State of Utah
DEPARTMENT OF NATURAL RESOURCES
DIVISION OF OIL, GAS AND MINING

August 28, 1992

RE: Permit Conditions, Five Year Renewal, Pacificorp Electric Operations, Des-Bee-Dove Mine, ACT/015/017, Folder #2, Emery Country, Utah

**DES-BEE-DOVE HAULROAD RECLAMATION STUDY
RUNOFF AND SEDIMENT YIELD MONITORING PROGRAM
PROPOSED TEST PLOTS**

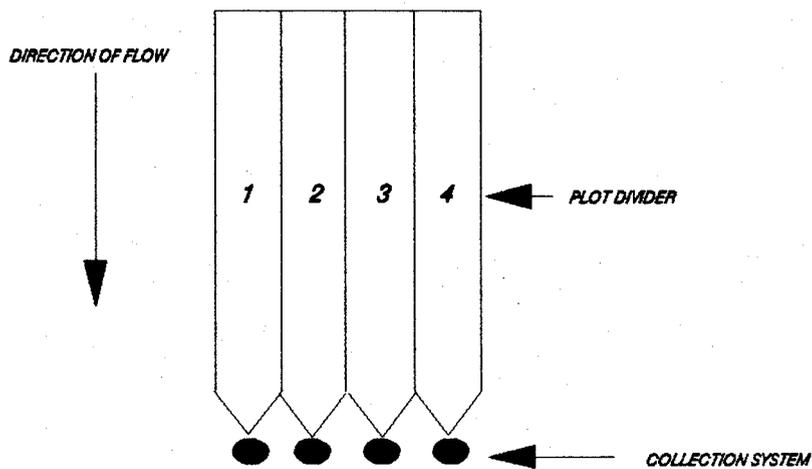
Required Action

The proposed sediment monitoring program is acceptable. The isolation of the plots, capturing all the runoff, drying the sediment samples and comparing the data with precipitation data is an accepted method of collecting worthwhile data on sediment yields for different plot treatments. The operator must submit a conceptual drawing showing dimensions and apparatus to be used in the second phase plot design in Appendix XVII.

The Des-Bee-Dove Haul Road Reclamation Study Runoff and Sediment Yield Monitoring Program and a drawing of the proposed Test Plot Sediment Collection System are found in Appendix XVI. This condition is satisfied.
